Change of labelling

Product Change Notification					PCN T9		D10-032-512
owner	creation date	release date	released by	change order no	rev	page	
schmidda	17.12.2018	17.12.2018	wullscdo	2016848	B	1 of 2

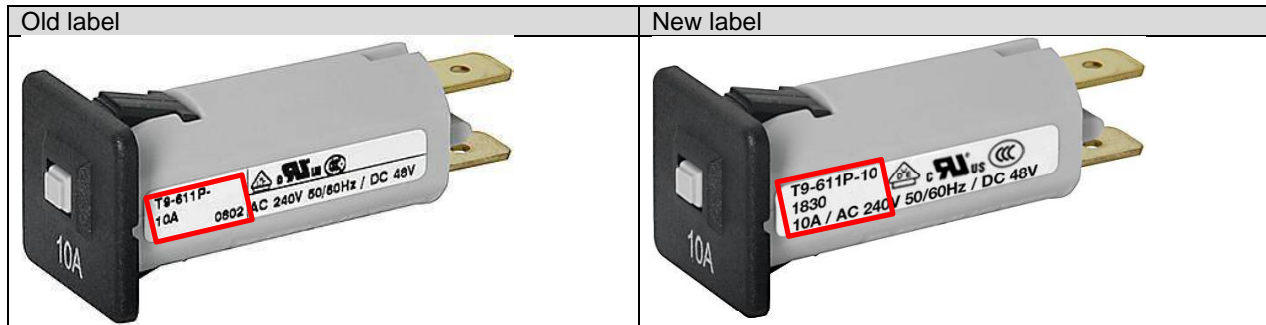
- Remove ending letter "A" to separate clearly the type designation from the rated current (e.g. old label "T9-611P-10A", new label "T9-611P-10")
- Included rated current in the AC/DC rating information.
- Rearrangement of Production Week and Approval labels.
